ADDENDUM NO. 2

August 12, 2022

Additions and Renovations Hawthorne Elementary School

This Addendum consists of Pages ADD 2-1 through ADD 2-3, Specification and Addendum No. 2 from CSO Architects dated August 12, 2022, consisting of three (3) pages, Specification Section 33 06 00 – Aqua-Swirl Stormwater Treatment System, and Addendum Drawing Sheets: AD201A, AD201BC, AD201D, A603, A702, A800, A801A, A801BC and A801D.

DRAWING TITLE:
**EXISTING
CONDITIONS
AND
DEMOLITION
PLAN**

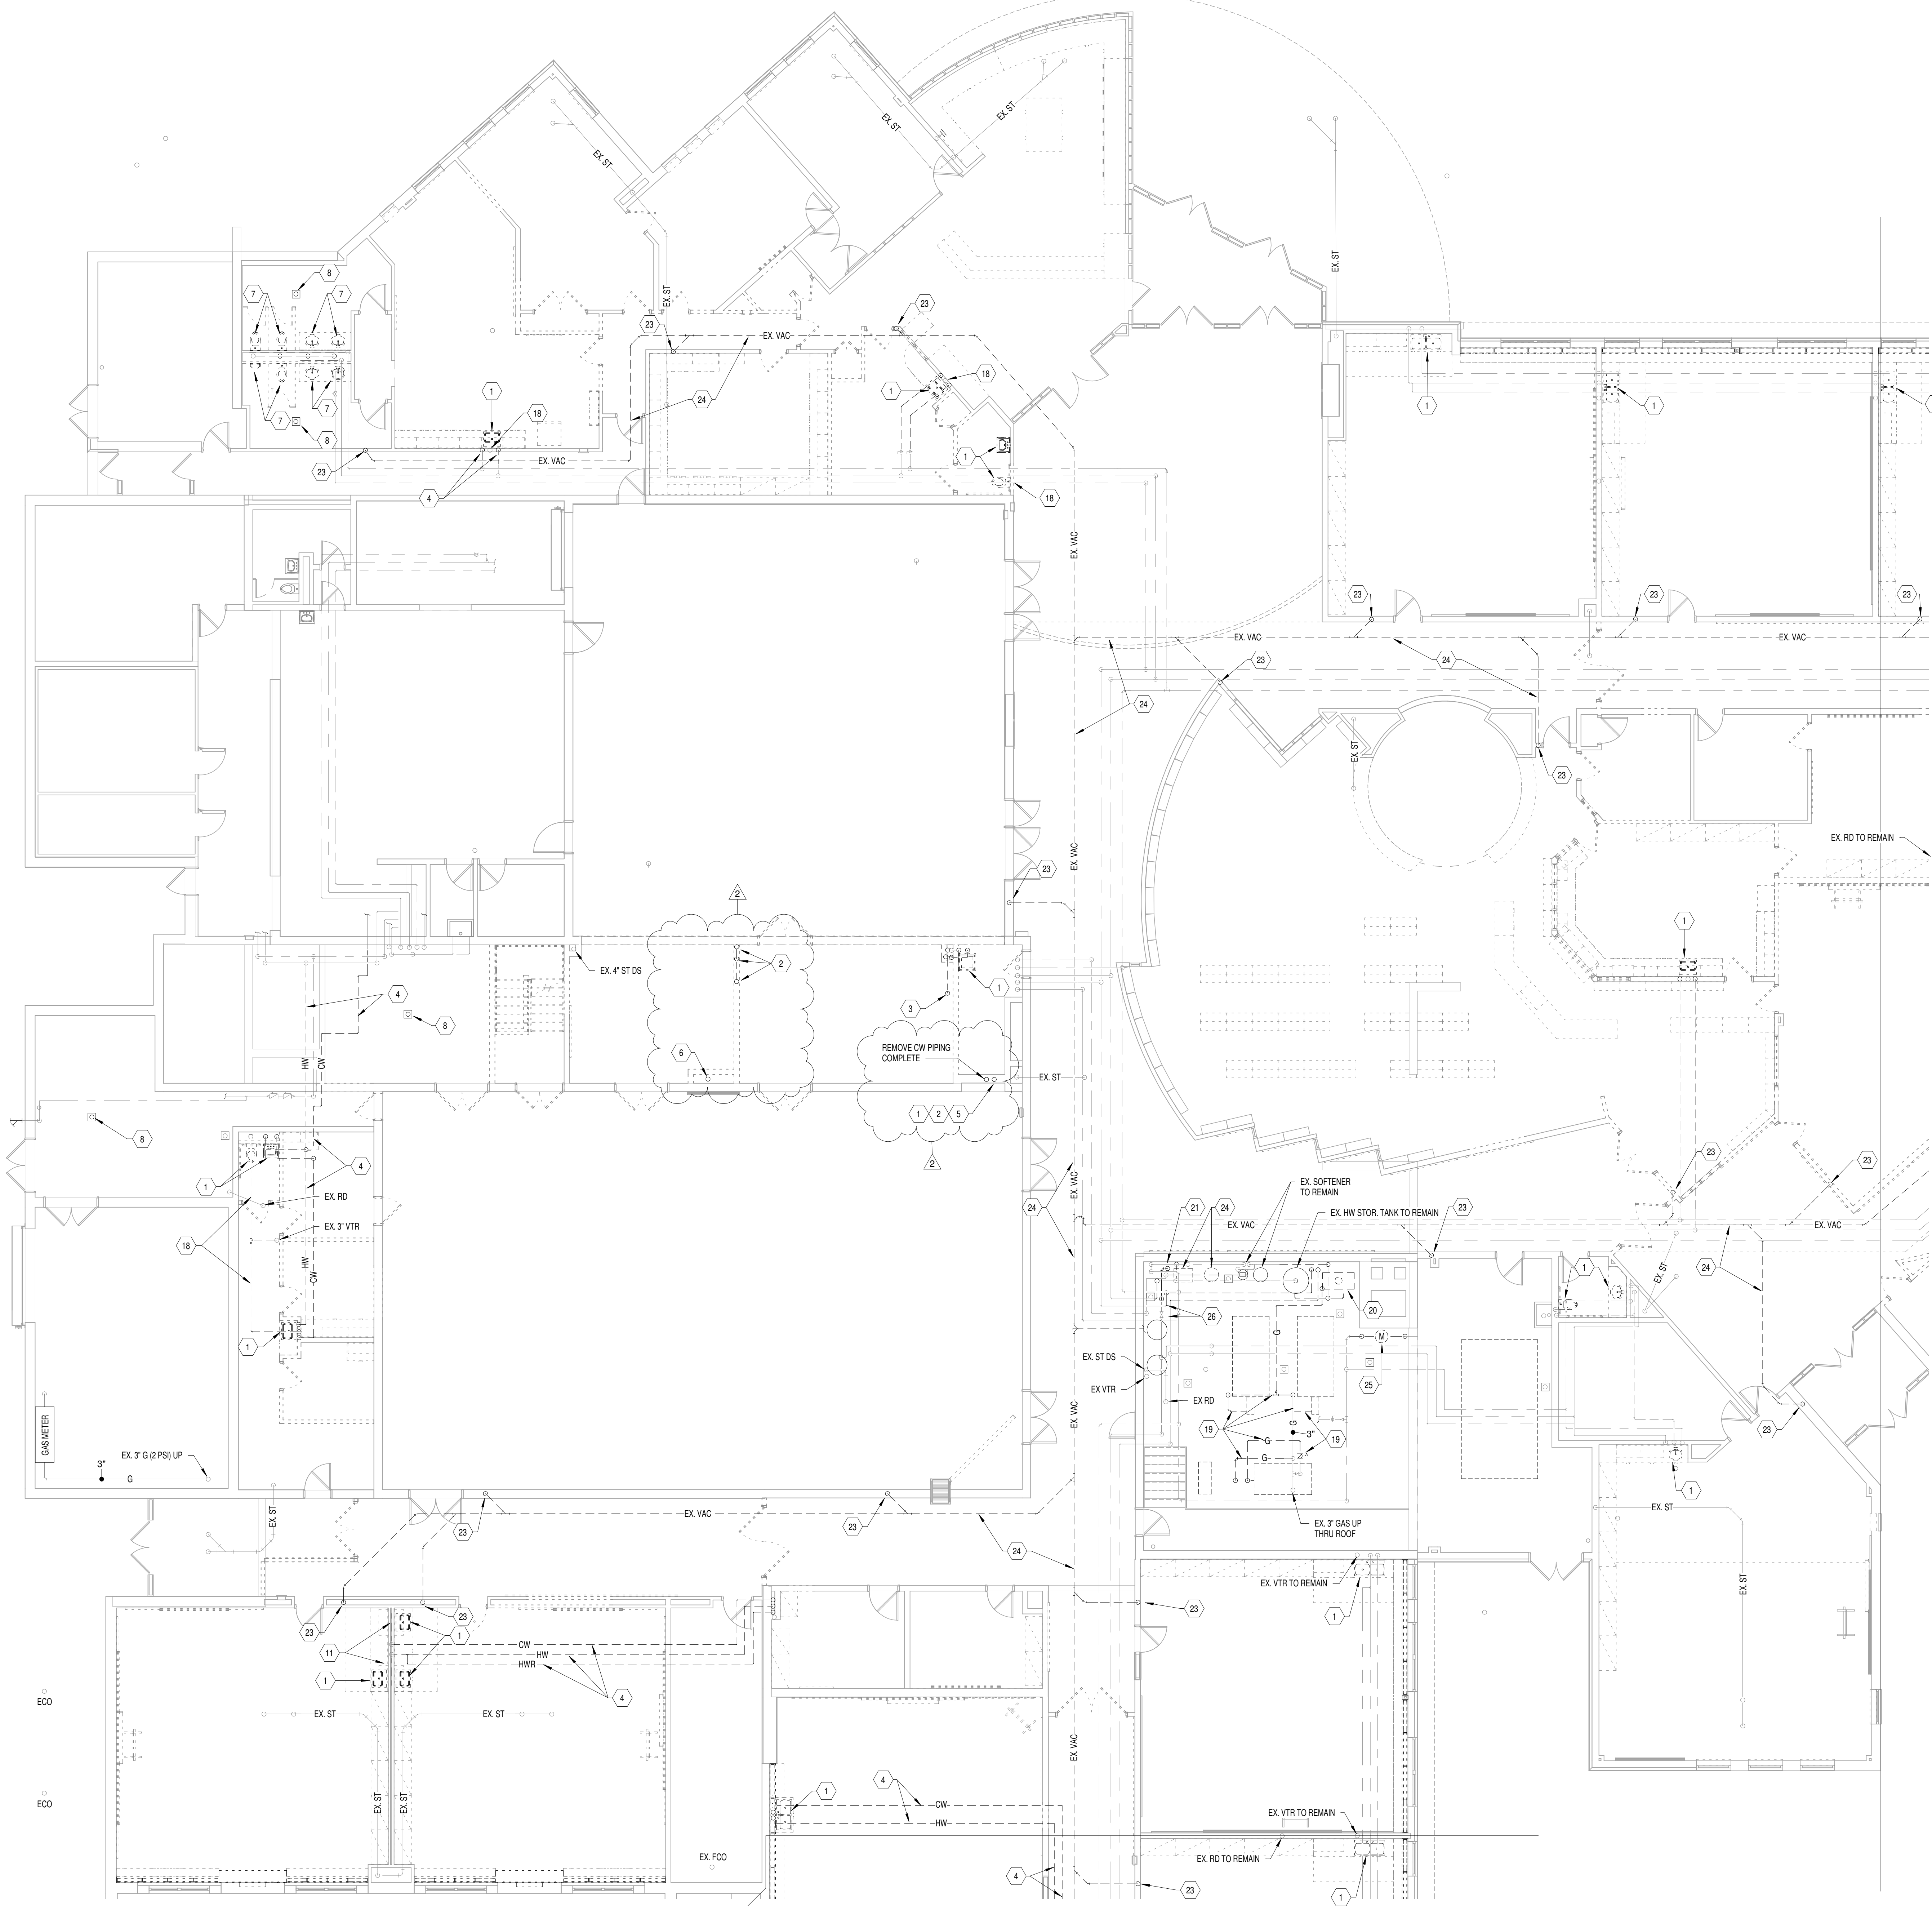
Revised items:

Sheet C101:

DRAWING TITLE:
**FIRST FLOOR
PLUMBING
DEMOLITION
PLAN - UNIT A**

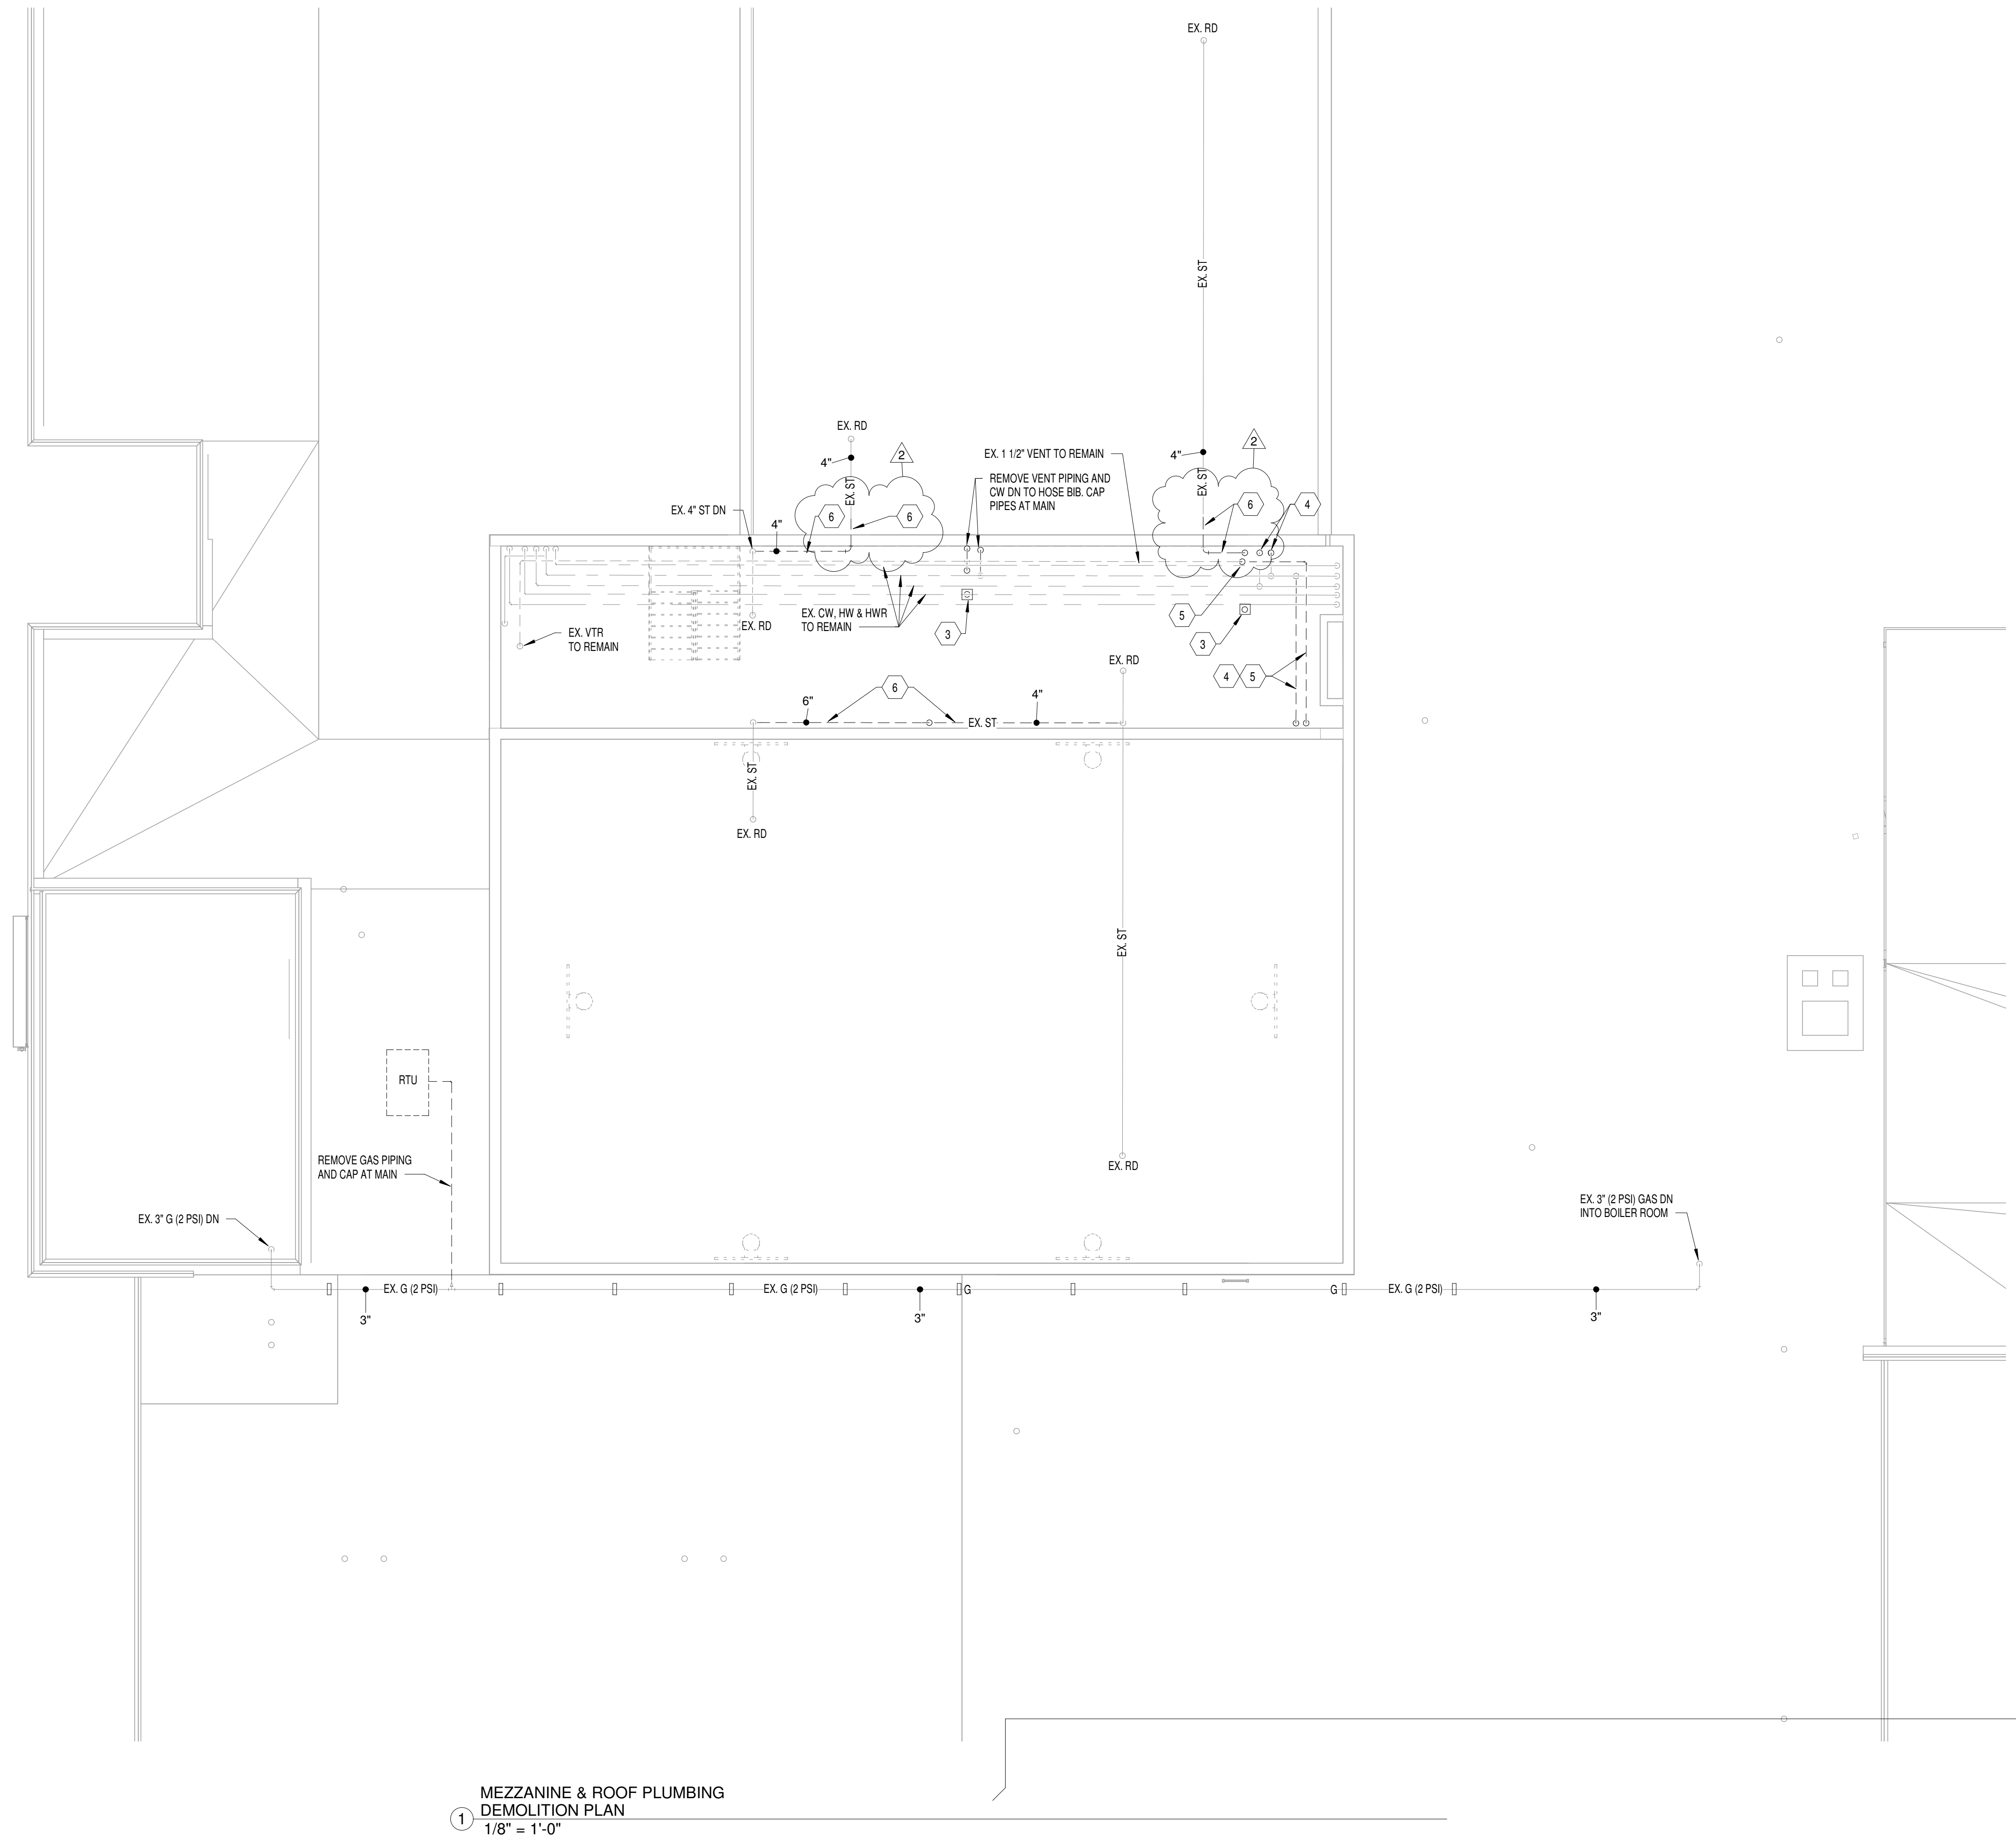
- Item 1. Sheet PD201A FIRST FLOOR PLUMBING DEMOLITION PLAN – UNIT A
 - A. Revised demolition piping and associated notes.
- Item 2. Sheet PD202A MEZZANINE & ROOF LEVEL PLUMBING DEMOLITION PLAN – UNIT A
 - A. Revised demolition piping and associated notes.
- Item 3. Sheet P202AD MEZZANINE & ROOF LEVEL PLUMBING PLAN – UNIT A AND D
 - A. Revised new storm pipe routing with noting.
